SITE DEVELOPMENT PLAN, AMENDMENT NO. 1

THE BRINKERHOFF & BAR HUMMINGBIRD

SITE DEVELOPMENT PLAN, AMENDMENT NO. 1
THE BRINKERHOFF & BAR HUMMINGBIRD
TOWN OF CASTLE ROCK PROJECT NO. SDP25-0007

CHANGES FROM APPROVED SDP
AMENDMENT #1

THE BRINKERHOFF & BAR HUMMINGBIRD
CASTLE ROCK PROMENADE, BLOCK 2
CASTLE ROCK, COLORADO 80108
SITE LIGHTING PLAN

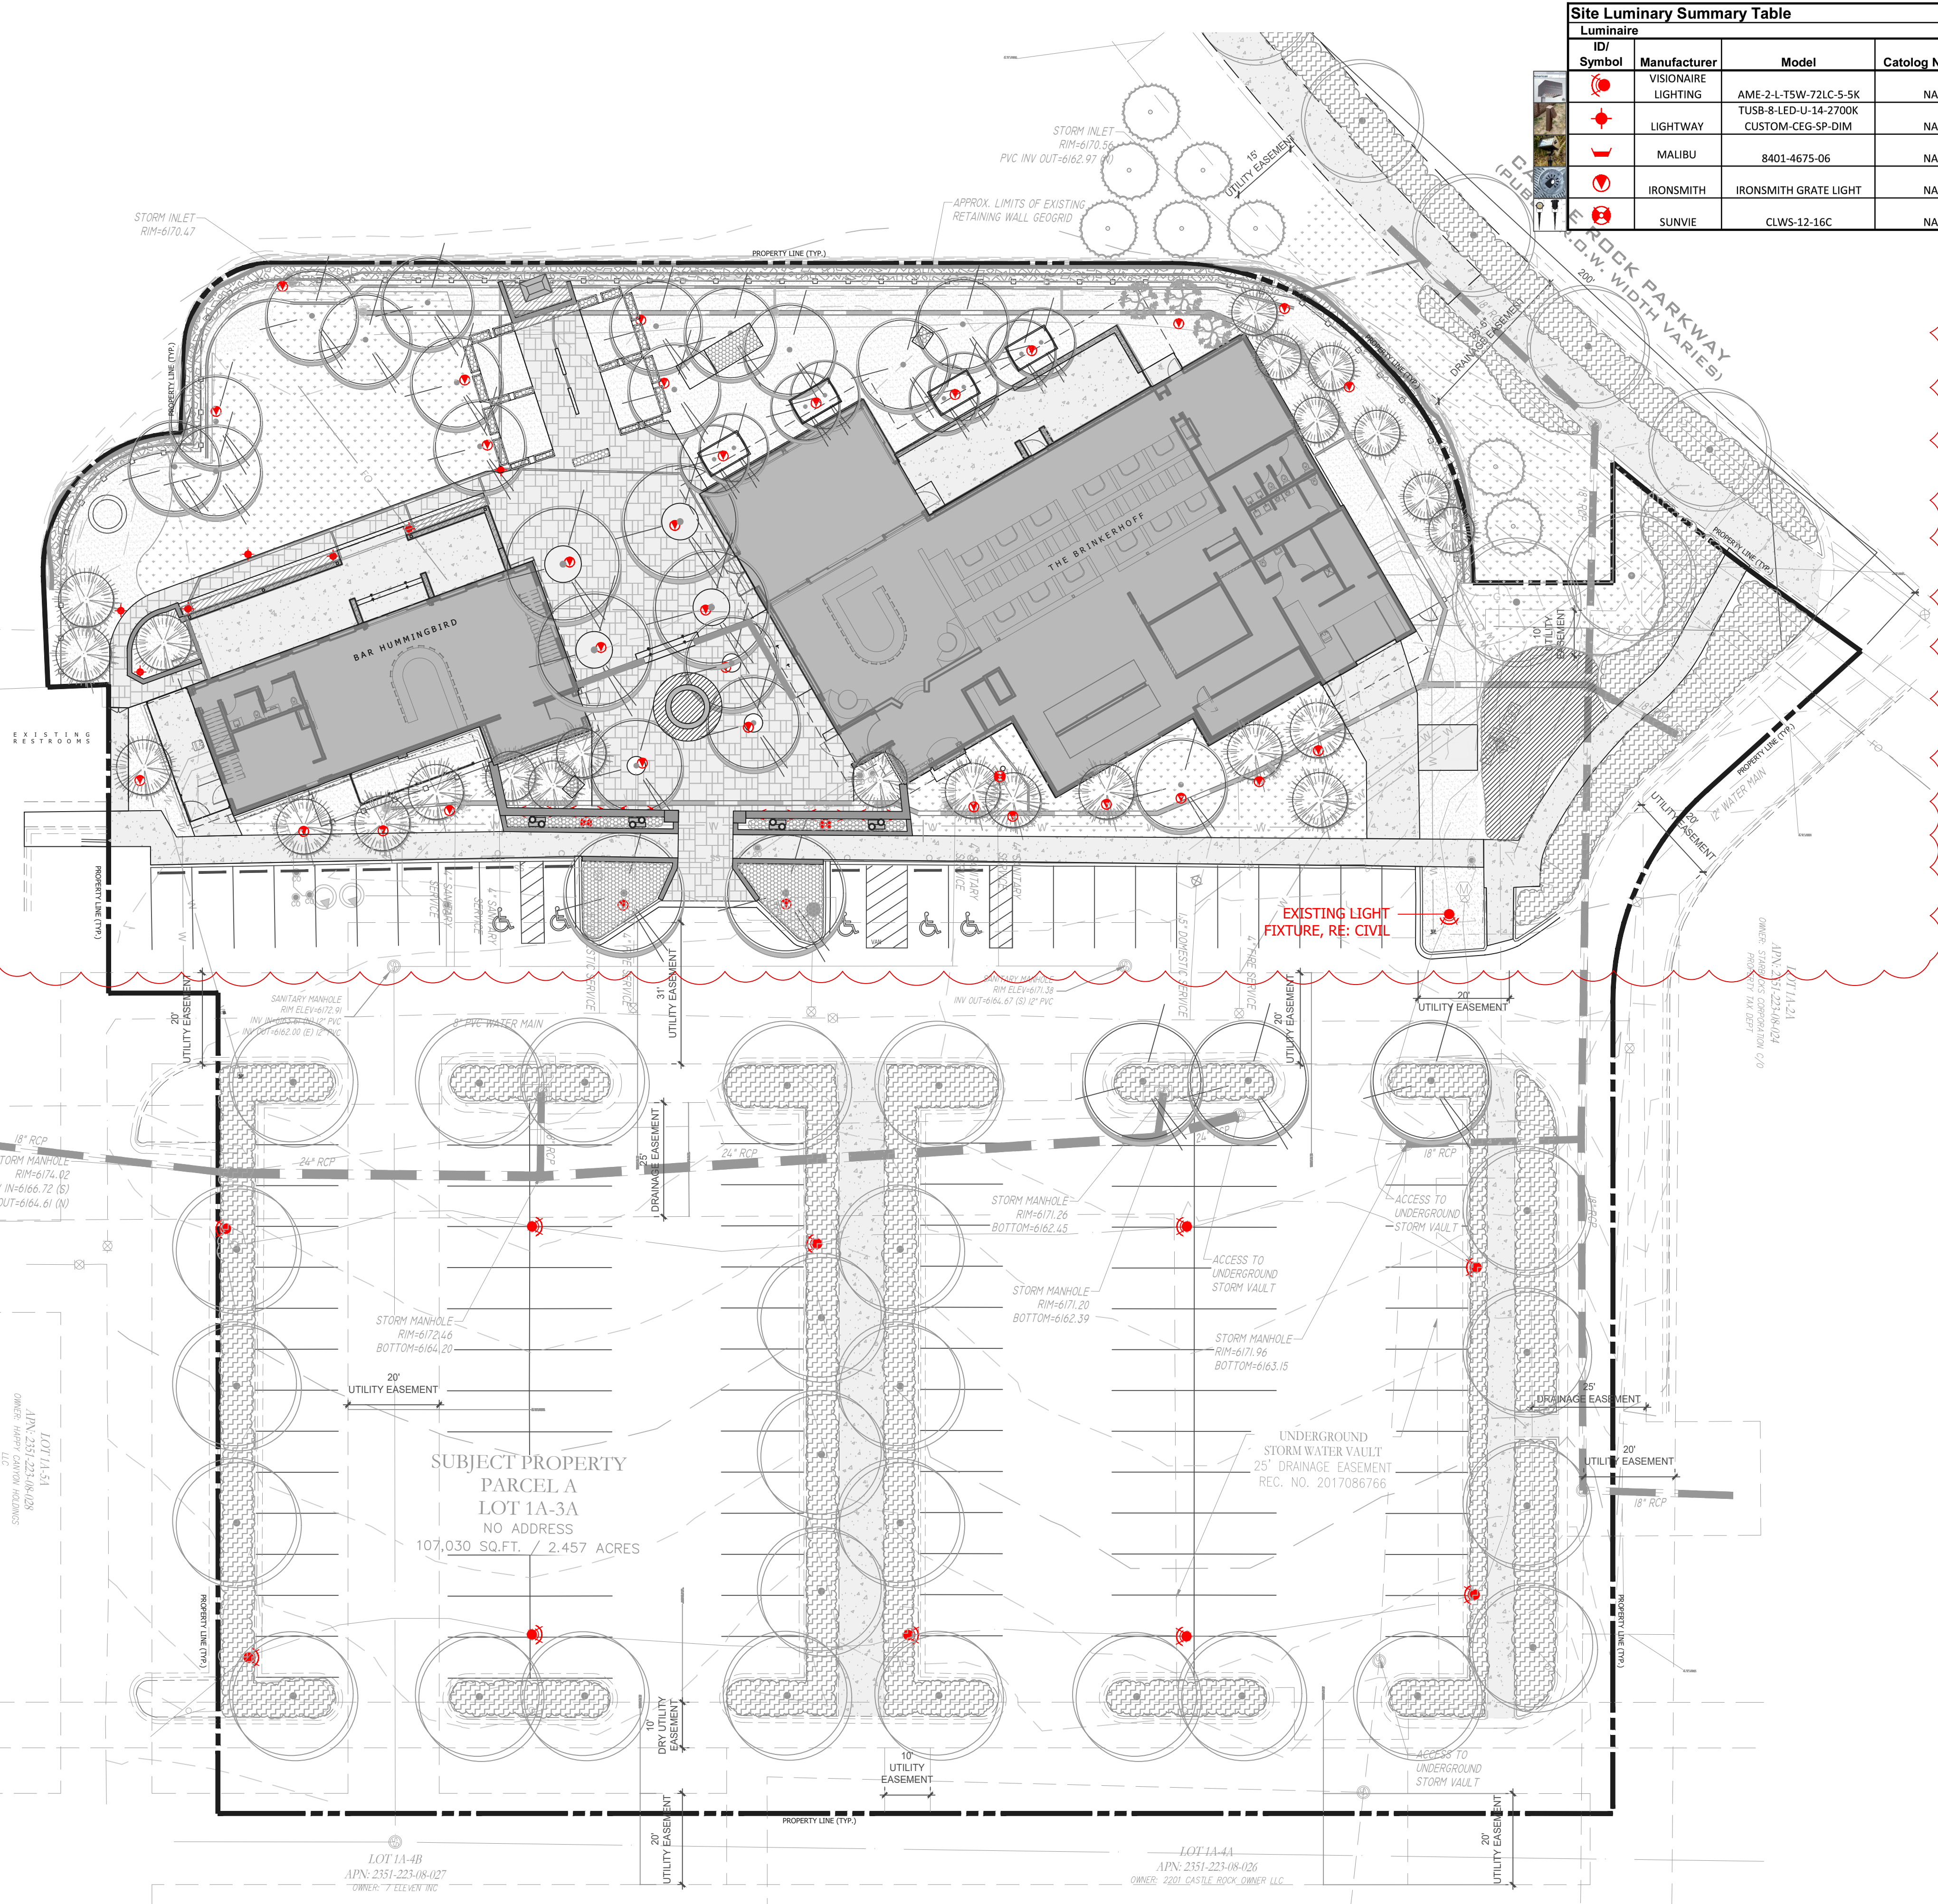
- LIGHTING CHANGES:**
- OVERALL LANDSCAPE LIGHTING WAS REDUCED FOR ENERGY SAVINGS AND TO PROVIDE MORE COMFORTABLE AMBIANCE FOR PATRONS.
 - TWO TYPES OF LIGHTING FIXTURES WERE REMOVED, THE STEP / CAP LIGHT FIXTURE AND OUTDOOR CHANDELIER FIXTURE. A NEW FLOODLIGHT WAS ADDED TO THE ENTRANCE WALLS TO PROVIDE MORE VISIBILITY TO THE ENTRANCE.
 - AN EXISTING LIGHT POLE IN THE PARKING LOT WAS SHIFTED FURTHER FROM THE CURB TO AVOID ANY VEHICLE COLLISIONS AND IMPROVE LINE OF SIGHT ON THE NORTH EAST CORNER OFF THE BRINKERHOFF.
